ADDENDUM NO. 1

PROJECT NAME: Nebraska Union First Floor Selective Refurbishment
UNL PROJECT NUMBER: C026P336
BID INVITATION NUMBER: 2209-13-7200

CONSULTANT: Holland Basham Architects
ADDRESS: 119 S. 49th Ave, Omaha, NE

DATE OF ISSUANCE: 20 August 2013
DATE OF BID OPENING: 27 August 2013

9 POLE BASE DETAIL
E5.1 NO SCALE

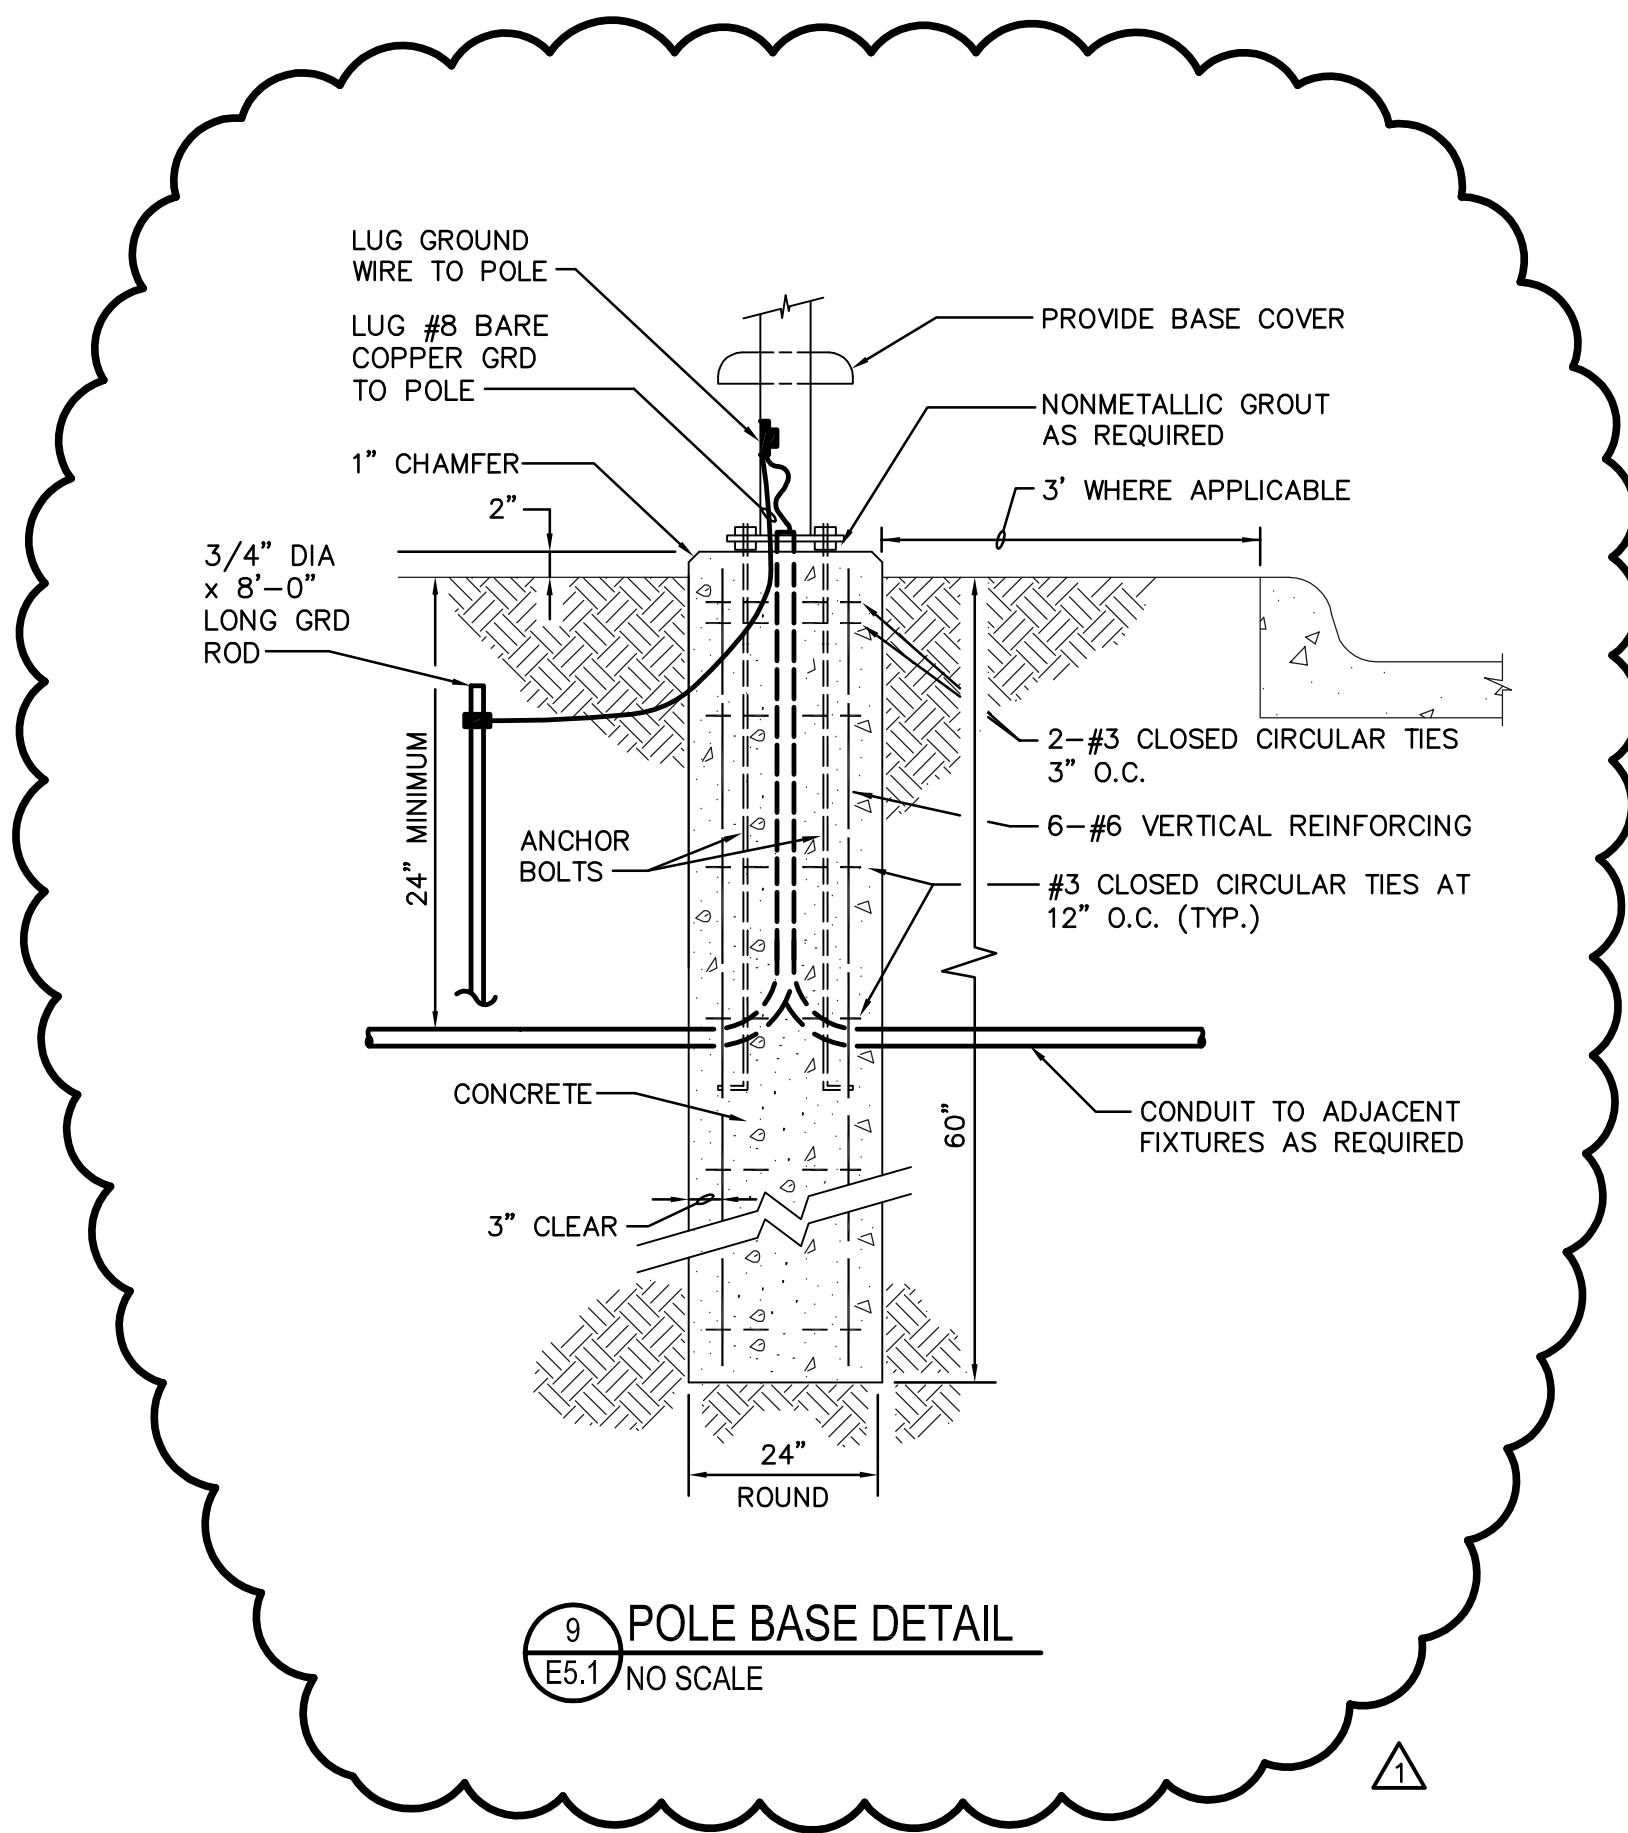
- a. Detail 9 – pole base detail added to sheet.
- b. Roof-mounted exterior photocell added to digital lighting control system.
